ADDENDUM NO. 4

CITY OF CORONADO

**GLORIETTA BAY DOCK C (CONTRACT NO. 17-CO-ES-621)
&
BOAT LAUNCH RAMP RECONSTRUCTION (CONTRACT NO. 17-CO-ES-622)**

September 6, 2016

Link and Photo of EZ-Dock:

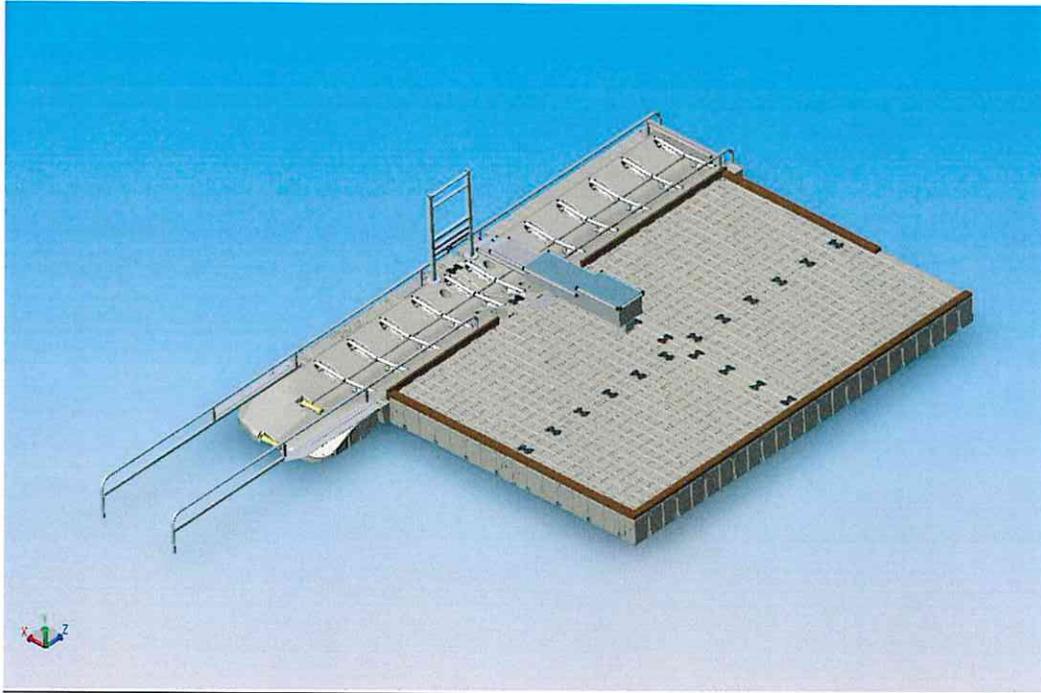
1. Question: Reference is made to Boat Launch Ramp Contract Drawing Sheet 11 of 17 – PUBLIC DOCK AND GANGWAY PLAN – Detail 1 / 11 – PUBLIC DOCK PLAN and to the note thereon – “ASSISTED KAYAK LAUNCH.” Please clarify if the “apparatus” shown within this detail is to represent a manlift for accessing the kayak launch. If so, please provide a detail.

23. Question: For Boat Launch Ramp project, please refer to Low Freeboard Dock drawing 11 of 17. It appears that a "pool lift" is required to be included in our bid. There are over "pool lifts" online [sic]. Prices from \$900 to \$6,000. Some require electrical connection. Please specify what is required.

Response: There are commercially available products from AccuDock (as shown below), EZ-Dock (as shown below), and GatorDock (not shown). None of the options listed are motorized. In order to not limit the low-freeboard dock material options, the Contractor has the option to select these or another commercially available product that is ADA-compliant, or the Contractor may elect to prepare shop drawings and fabricate their own product conforming to the Contract Specifications in Section 35 51 13 – 2.11. The product shall have a transfer platform, transfer steps, and a grab bar.
